ADDENDUM NO. M03

1.1 AHU-9 REVISIONS

**RCMP
D-DIVISION**

2 SUPPLY AIR HANDLING UNIT (AHU-09) DETAIL

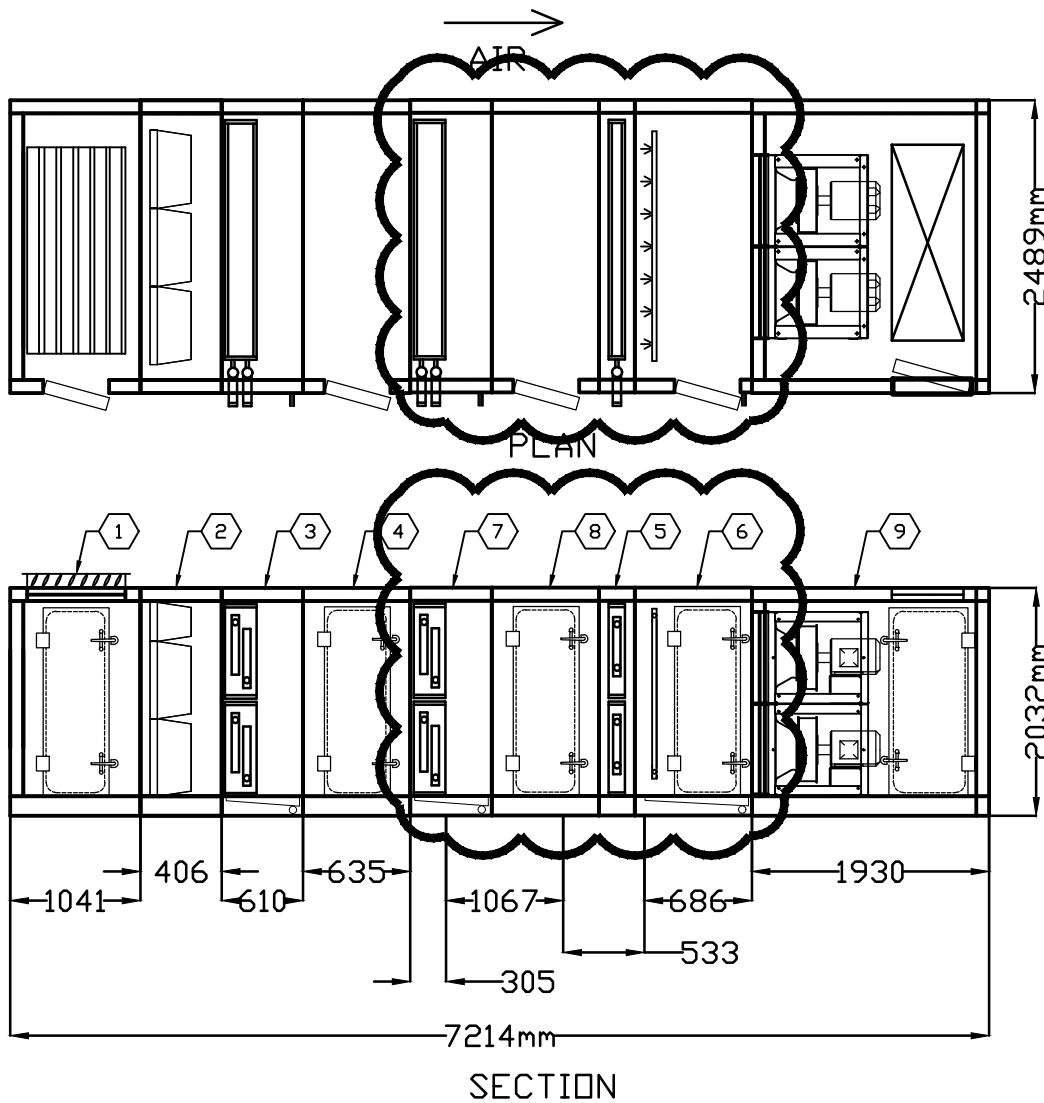
Reference: Mechanical Drawings, and Specifications for AHU-9

- .1 Humidification:
 - .1 Revise humidification capacity to 380 lb/hr. Capacity to be sized for Winnipeg winter design entering conditions and leaving conditions of 70F at 30% RH.
 - .2 Building steam is 5-10 psi.
- .2 Dehumidification:
 - .1 Revise leaving air temperature to on coil to 60F Dry Bulb and 59F Wet Bulb for dehumidification. Adjust flow rates to achieve leaving air conditions.
 - .2 Switch position of heating coil and humidifier with cooling coil to allow for reheat. Position from upstream to downstream to be cooling coil > heating coil > humidifier. Refer to attached drawing revision M1.1R1
- .3 Reclaim Coil Clarification:
 - .1 Disregard leaving air temperature of 70 F in schedule.
- .4 Fan Section:
 - .1 Provide back draft dampers (4 total), one per fan.

3 EXHAUST AIR HANDLING UNIT (AHU-13) DETAIL
M1.2 M1.2 NOT TO SCALE

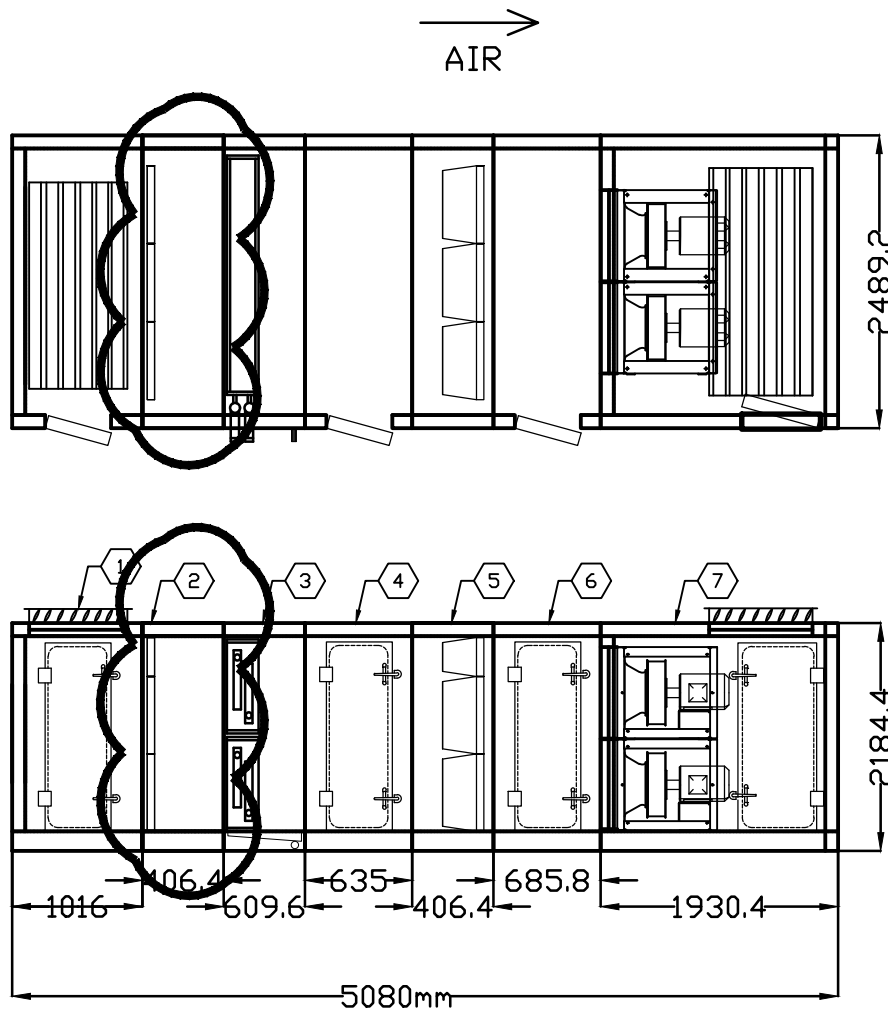
1.2 AHU-13 REVISIONS

Reference: Mechanical Drawings, and Specifications for AHU-13

- .1 Filter Section:
 - .1 Revise filters to 2" before reclaim coil and HEPA down stream of reclaim coil. Refer to attached drawing revision M1.1R2
- .2 Fan Section:
 - .1 Provide back draft dampers (4 total), one per fan.
